15-24-01 - Cylinder Head Cover Leaking

Release date: 9/19/2024

## Technical Background

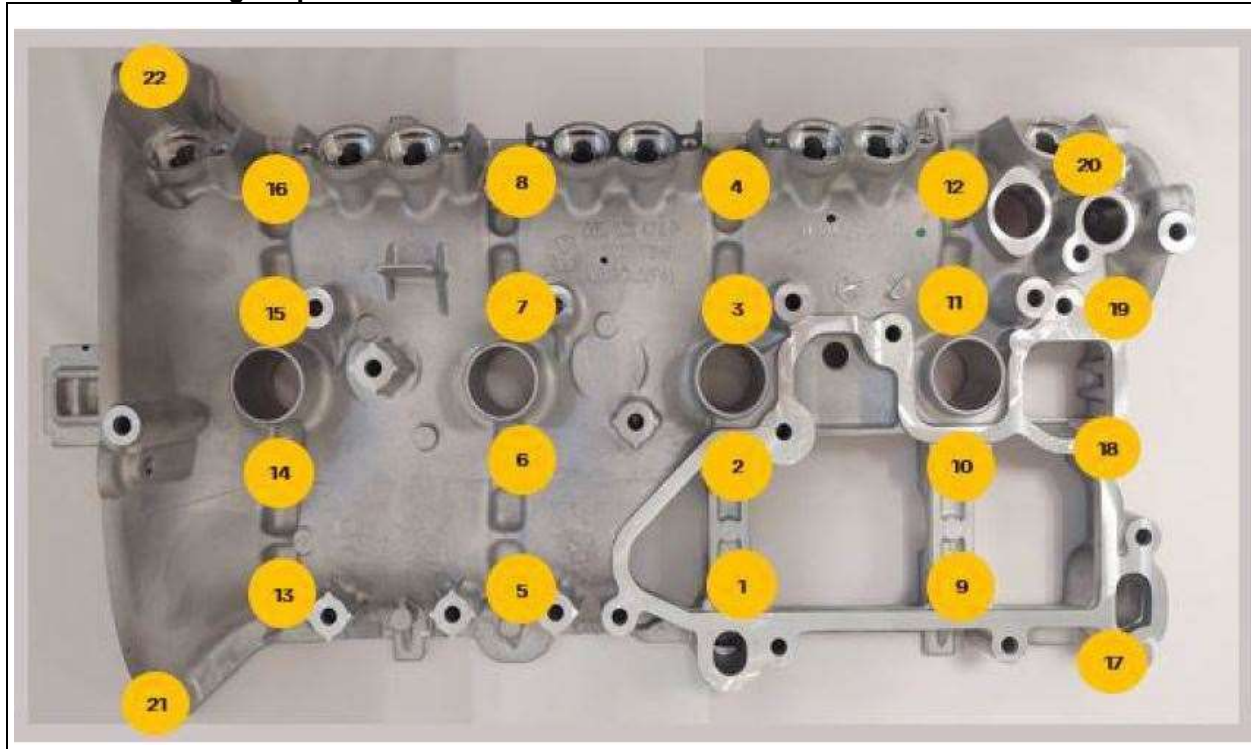
**Please check all 22 cylinder head cover bolts.**

**The oil separator must be removed.**

**Check that the cylinder head cover bolts are tightened to a torque of 14 Nm in the order shown in the illustration below.**

If, while checking the cylinder head cover bolts, they are tightened to 14 Nm, if torque wrench does not click after a quarter turn (90°), the affected bolt must be replaced.

Replace any loose bolts.

Tighten the new bolt(s) to a torque of 8 Nm + 90°.
